LAKE WYNONAH DAM

PHASE I INSPECTION REPORT NATIONAL DAM INSPECTION PROGRAM

LAKE WYNONAH DAM
SCHUYLKILL COUNTY, PENNSYLVANIA
NATIONAL I.D. NO. PA 00702

✓ WOODWARD-CLYDE CONSULTANTS
5120 Butler Pike
Plymouth Meeting, Pennsylvania 19462

SEEPAGE LOCATION PLAN
LAKE WYNONAH DAM
SHEET 5a OF 11

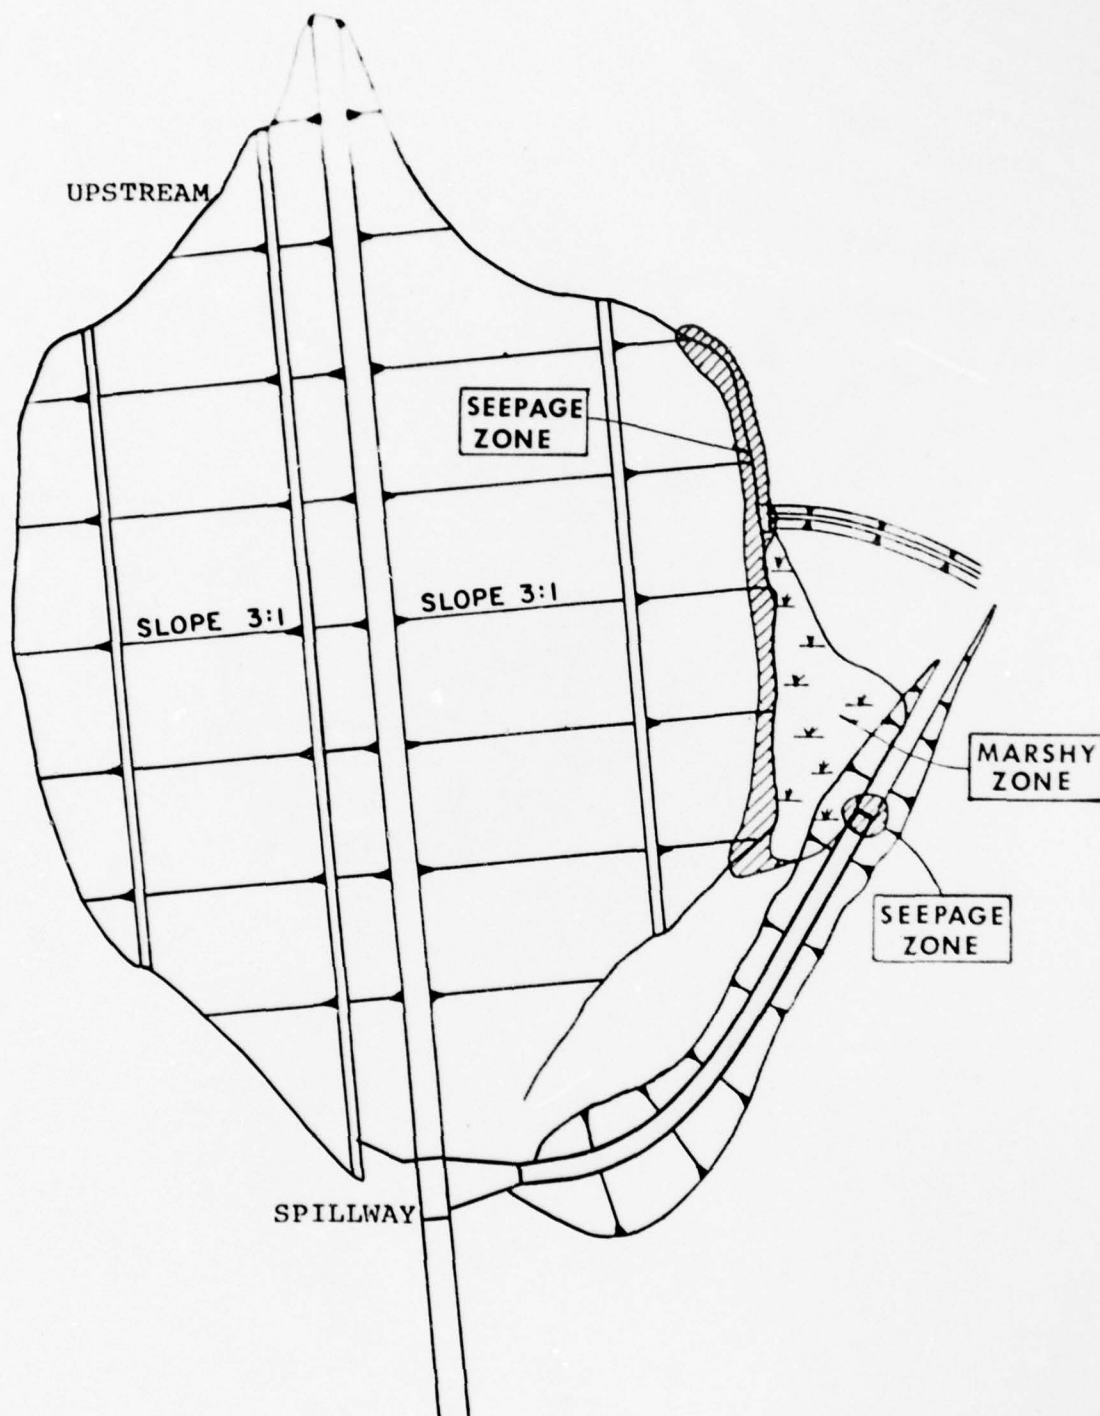
As shown on Sheet 5a, Appendix B, standing water was observed below the downstream toe on the right side of embankment. It is assumed, based on previous inspections, that this standing water has existed for several years and has remained unchanged. Considering the pervious downstream embankment materials and the blanket drain, seepage is expected to occur along the base of the dam and, perhaps, up the slope for a small distance. This seepage does not appear to indicate hazardous conditions, although it should be monitored for rates of change or increases in turbidity.

The visual inspection disclosed no evidence of apparent past or present movements to indicate instability of the dam. The wet areas noted on Sheet 5a, Appendix B are to be expected considering the type of materials and drainage system incorporated in the embankment.

1. The seepage discharging around the pond drain outlet works and adjacent areas should be monitored for increases in flow or changes in turbidity.
2. Considering the quantity and locations of seepage through the embankment, it is recommended that a series of piezometers be installed perpendicular to the dam axis through the maximum embankment section to delineate the phreatic profile. The profile should be evaluated by a registered professional engineer.

VIEW OF CRACKED OGEE SECTION
ADJACENT TO LEFT WING WALL.
HORIZONTAL CRACKS WERE NOTED FURTHER
DOWN THE WEIR. NOTE HIGH WATER
MARKS ON THE WINGWALL

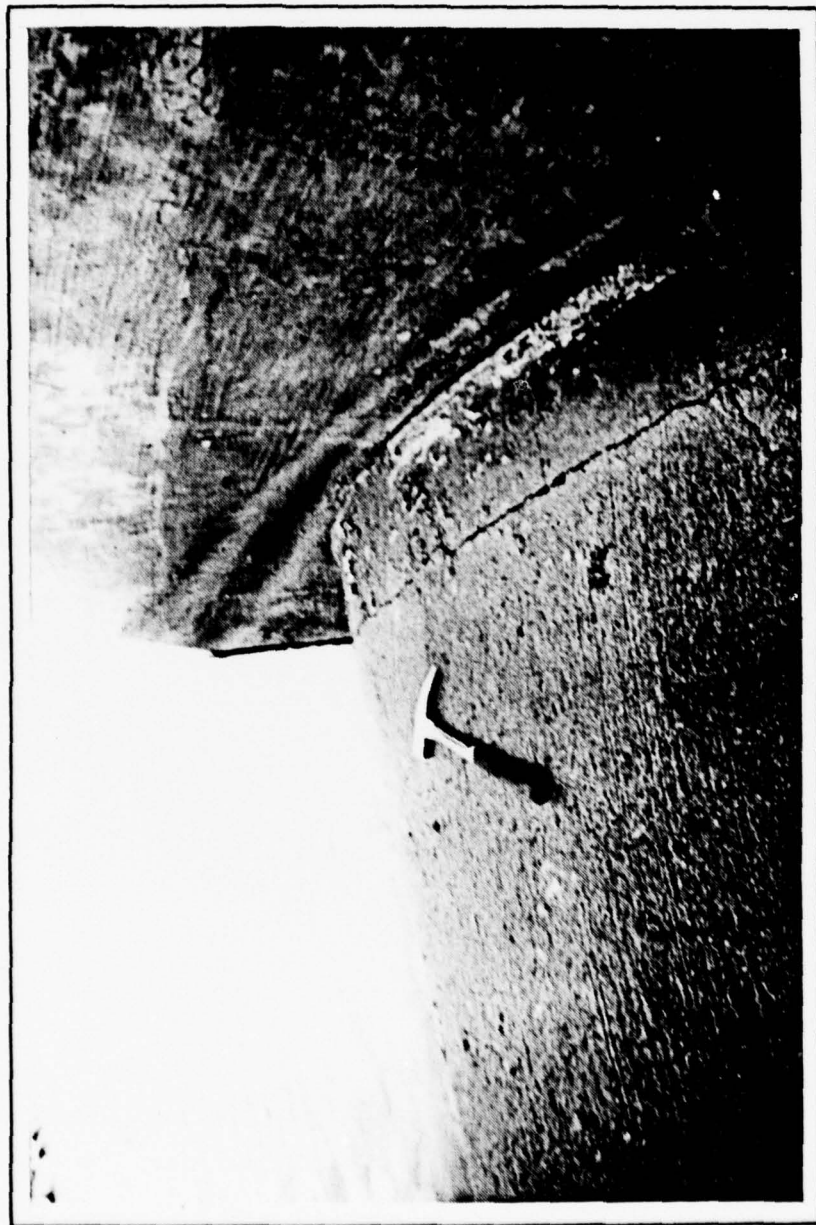
2. Spillway. The spillway weir was observed to be in relatively good condition. However, there were some cracks noted along the left retaining wall and horizontal cracks located along the left side of the weir. Signs of past seepage were noted through many of the cracks. The approach channel retaining walls have rotated. See Photograph No. 8. This movement was observed during a State inspection performed in September, 1977; and the State inspector recommended that the movement be monitored. Along the spillway chute several diagonal cracks and occasional vertical cracks, generally located between construction joints, were observed. Occasional wall rotations were also observed between construction joints. At the base of both chute spillway walls fillet concrete was noted to be deteriorated and broken at several locations. Sections of the fillet concrete up to 2 or 3 feet long were dislocated and scattered along the chute. It is apparent that this fillet was never bonded to the chute slab or the retaining wall or separation cracks were also noted at the base and sides of the fillet along the entire chute.

The cracks and rotation noted on the spillway walls were interpreted to be the result of the design. The pond drain was assessed to be in good condition.

4. Cracks along the weir chute walls and chute slab should be monitored; and if seepage is observed through these joints, the joints should be sealed.
5. The boat marina, located upstream of the emergency spillway, should be assessed and appropriate measures taken to minimize the possibility of the docks or boats floating downstream and clogging the spillways during storms.

DISPLACEMENT OF WINGWALLS AT
CONSTRUCTION JOINTS WERE NOTED
AT SEVERAL LOCATIONS ALONG THE
SPILLWAY CHUTE

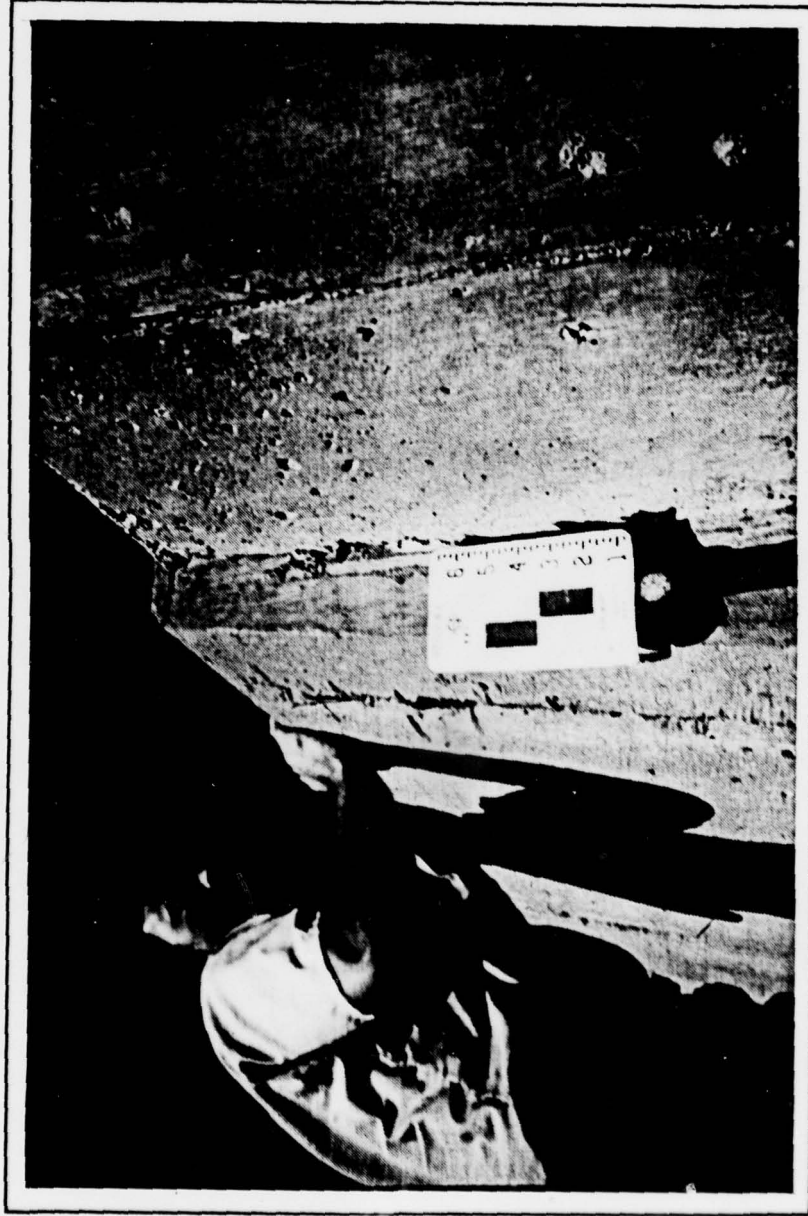
The cracking and rotation noted on the spillway channel walls is undesirable but is not considered to be indicative of potentially unstable conditions. Wall rotation should be monitored regularly. A review of the calculations revealed that the ACI code when compared to Soil Conservation Service requirements does not provide sufficient temperature and shrinkage reinforcing steel for hydraulic structures. This accounts for the cracks.

3. Rotations noted along the spillway chute retaining walls should be periodically monitored. Should excessive deflections be observed as determined by a registered professional engineer, appropriate remedial measures should be taken.

CRACKED WINGWALL ALONG SPILLWAY CHUTE

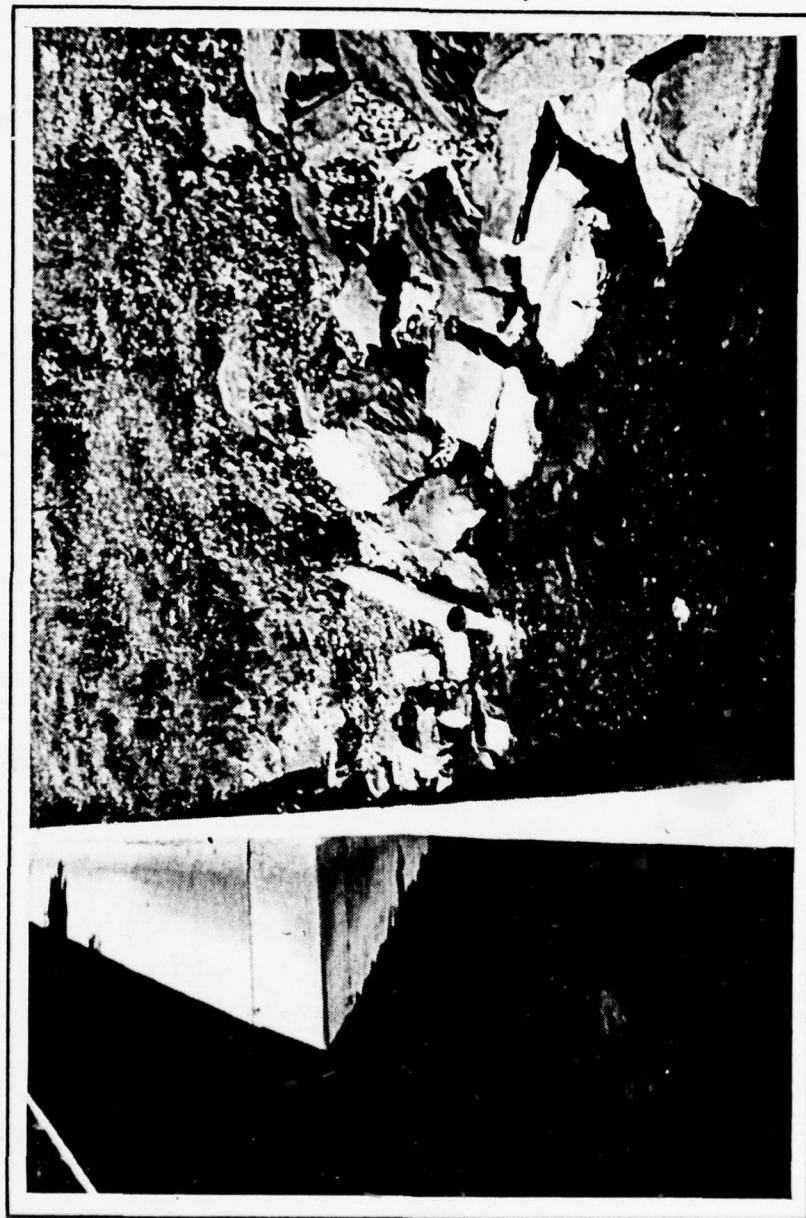
The spillway system, which includes the weir, chute, slab and retaining walls, was inspected and, in general, found to be in good condition. Cracks and movement were observed in the wall panels and construction joints, respectively. It is assessed that the cracks noted in the retaining walls are shrinkage cracks because they were designed by ACI codes which do not provide sufficient steel for hydraulic structures. The footings for these walls were evaluated to be slightly too narrow and may be a contributing cause for panel rotations about the base of the wall. In addition, the upstream backfill consists of clayey materials which can also cause the walls to rotate. It is judged that this wall movement will probably continue because of the clay backfill. Therefore, it is recommended that these walls be monitored. Cracks noted in the spillway should be monitored and if seepage occurs, they should be sealed.
